RE: Noise Impact Review, of Noise Report for
Cherry Creek Events Center
EDI Job # C-4385

Please find below Engineering Dynamics' review of the Cherry Creek Event Center noise impact report by Cerjan Consulting. See attached.

NOISE ASSESSMENT OF PROPOSED FRANKTOWN EVENTS CENTER

Figure 3.1: Realistic Cherry Creek Event Center 35 dBA Noise Contour

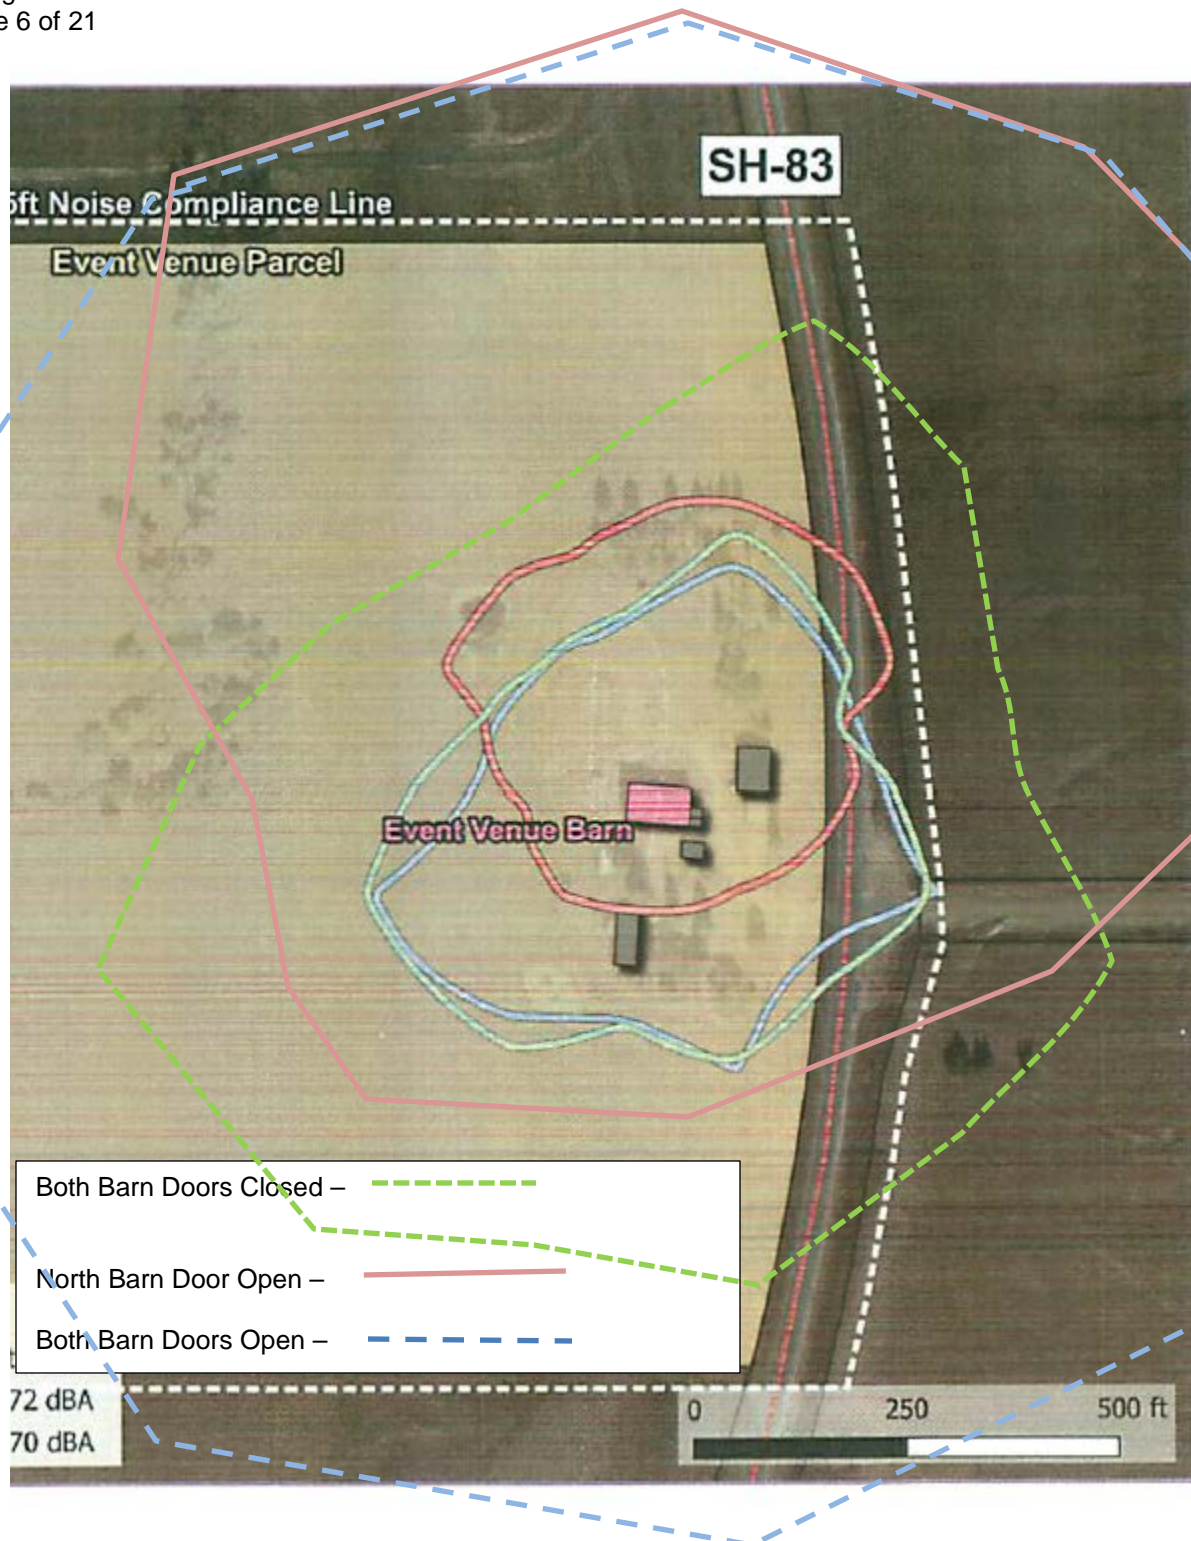
Figure 3.1, of this report shows expected realistic 35 dBA noise contour location for Event Center operations, with amplified music and voice noise levels at 90 to 100 dBA. Inspection of Figure 3.1 shows that, with realistic noise levels, the Event Center is NOT in compliance with Douglas County Zoning Resolution, Use by Special Review, Section 2107.14 Event Center, Noise Limits.

Additionally, with realistic noise levels inside the 'barn', noise levels at five of the seven residences modeled in the Cerjan report will have noise levels in excess of 35 dBA.

Recommendation: The noise report for the Cherry Creek Events Center needs to be re-done with realistic indoor noise levels from amplified music and voice, and needs to include noise impact from outdoor gathering / event area.

Figure 3 – Predicted Noise Level Contours for the Proposed Events Venue

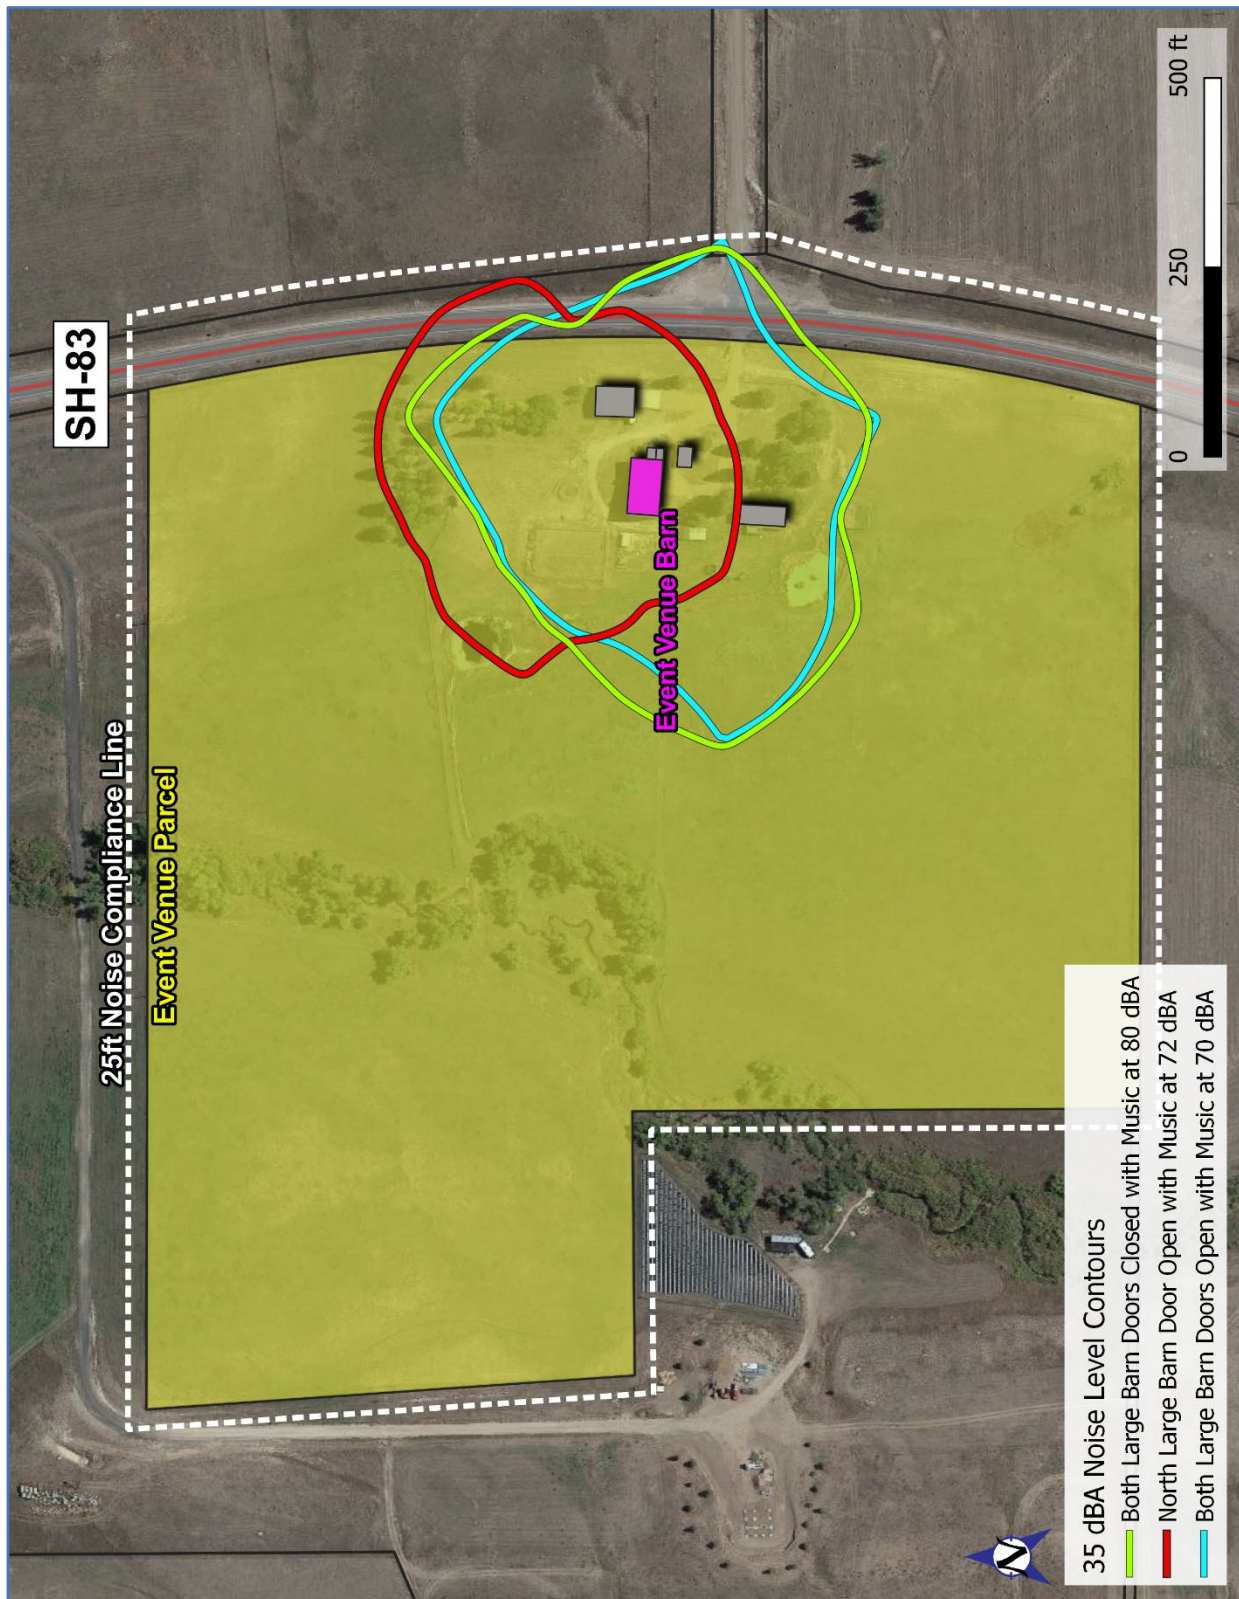
Note: Section 5.0, Table 3 and Figure 3 of the Cerjan report show predicted noise levels at nearby residences and the Event Center property lines. Figure 3, shows predicted noise contours with the barn doors open, and with a note indicating noise levels inside the barn at 70 and 72 dBA. The narrative in Section 5.0 does not mention this operational reduction in noise levels for conditions when the barn doors are open.

As discussed in Section 2.0 of this report, the assumed maximum noise levels inside the 'barn' are on the order of 10 to 20 dBA less than is typical for weddings, graduations, etc. in this type of events center. With noise levels at events in the 90 to 100 dBA range the noise contours show in Figure 3 of the Cerjan report, will extend out two to four times further than shown.
